### PLANNING COMMISSION AGENDA

MAY 6, 2024 at 7:00 PM

## **CENTRAL BANK**

Project #: PL24-06F Location: Southeast Corner of Prairie Star

C101

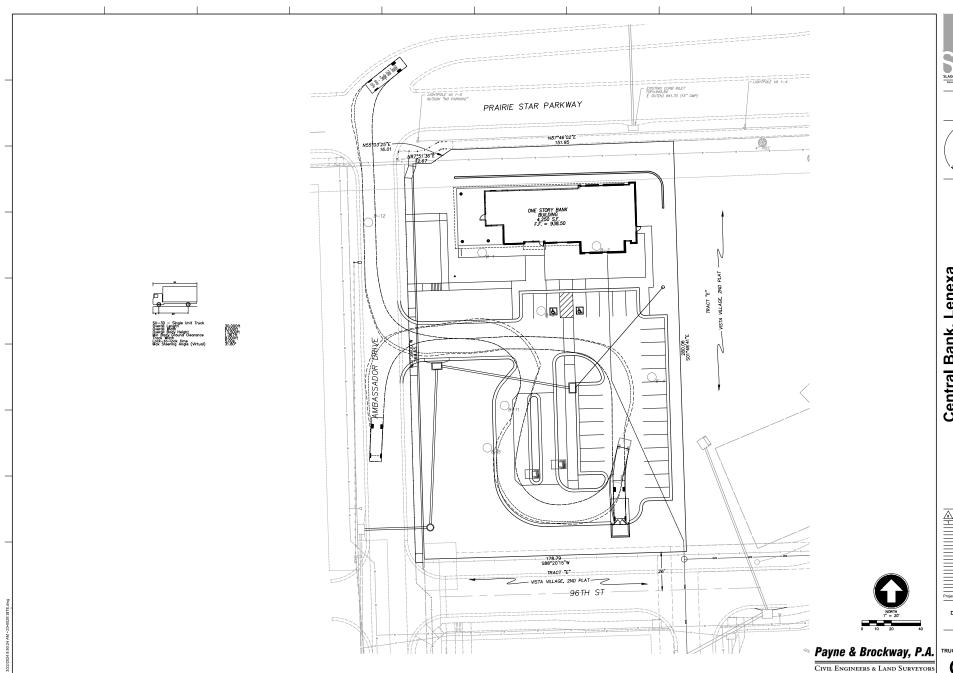
Staff has identified concerns with the Truck Maneuvering Plan (SU-30), a plan which is required to demonstrate how a 30-foot single-unit truck can navigate the site. Additionally, it serves to establish site dimensions for parking and accessibility of various vehicular and pedestrian users. Generally, it is recommended to "accommodate" rather than "design for" such vehicles, especially when they are not the primary users of a site. It is acknowledged that the applicant attempted to accommodate the truck rather than specifically designing for it.

In the original truck maneuvering plan, as illustrated in Exhibit 3, the truck is depicted running over curbs throughout the site and clipping the canopy of the western ITM machine, despite the inclusion of a bypass lane. To address Staff's concerns, the applicant was advised to consider reducing the number of parking spaces (which exceed the code-required amount by 11) to allocate more space for improving curb radii and overall site dimensions, thus enhancing maneuverability, and minimizing the risk of damage to the ITM canopy, landscaping, and curb integrity.

Revised plans, as illustrated in Exhibit 4, show evidence of the applicant's efforts to better accommodate a 30-foot truck by adding clearance for the ITM canopy. However, there is still insufficient curb clearance, resulting in the truck running over curbs throughout the site. Furthermore, in addition to the outstanding issues with truck maneuverability, Staff did not receive requested information regarding the internal traffic circulation.

As of the writing of this report, Staff has not received updated plans addressing these concerns. Staff requests that the applicant continue to work with Staff to address outstanding issues relating to the SU-30 plan and traffic circulation before the issuance of a building permit as a condition of approval for this project.

- 1. Prior to the issuance of any development or building permits, the applicant shall work with staff to address the following:
  - i. Resolve issues concerning internal traffic circulation as indicated on the truck maneuvering plan (SU-30 turning template).
  - ii. Revise the elevations and plans of the ITM machines to better harmonize with the architectural style of the bank, ensuring seamless integration with the overall development, as outlined in the Vista Village Design Guidelines and the UDC.
  - iii. Provide certification demonstrating compliance with a previously conducted mine study for this parcel or submit an appropriate mine study for review and approval.
